HISTORIC PRESERVATION BOARD STAFF REPORT		
18 NE 7th Street		
Meeting	File No.	Application Type
December 16, 2020	2020-208	Certificate of Appropriateness & Variance
REQUEST

The item before the Board is in consideration of a Certificate of Appropriateness & Variance (2020-208) request associated with the construction of a one-story addition and exterior alterations to an existing non-contributing residence on the property located at **18 NE 7th Street, Del-Ida Park Historic District**.

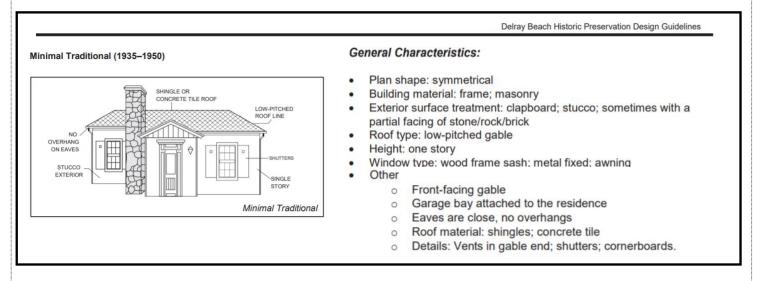
With regards to Architectural style. The LDRs state that all major and minor development shall consist of only one architectural style per structure or property and not introduce elements definitive of another style.

The existing style of the structure is Ranch and the architect has proposed changing the style to Minimal Traditional.

There is major concern with changing a Ranch style structure to a "Minimal Traditional" style.

- First, the sheer size of the existing Ranch structures façade does not equate to the Minimal Traditional style, as a Minimal Traditional structure would not have a sprawling façade.

- Second, the two new low opposing gables on the front façade including the new front porch addition are not characteristic in the Minimal Traditional style. The new gable introduce exposed beams that are more stylistic of the Bungalow style.

- Additionally, and most importantly, elimination of the Ranch style on this non-contributor, (which qualifies to be reclassified as a contributing structure), will exclude the structure from being part of the historic fabric of the Del-Ida Park Historic District. While the investment being made to upgrade the home is a positive for the district, the fabric of the district is being altered. If a similar structure were proposed as new construction in the district, HPB would need to consider if the style is appropriate for the district and if it would contribute to the longevity of the district. There would be hope that the new structure would be looked at in 50 years as a potential contributing structure. Alteration of the subject structures' façade makes the building vulnerable to demolition in the future. The homeowners and architect have an opportunity to make modifications to the structure that fit in with the Ranch style, ensuring the structure can be classified as a contributing with the Historic Resource Survey that is in process.

- Finally, modification of the style of the structure does not meet the requirements of this code section as the proposal **introduces elements definitive of another style.** Blending of two different styles, and the alteration of an original architectural style to be converted into a

completely different style is not an appropriate nor authentic method of preservation or rehabilitation. Should the request be approved, the structure will be of a style that is not definable and obvious that it was modified from its original style.

Therefore, the introduction of a new architectural style to this Ranch style structure is not an appropriate alteration of a potential contributing structure located with a historic district.
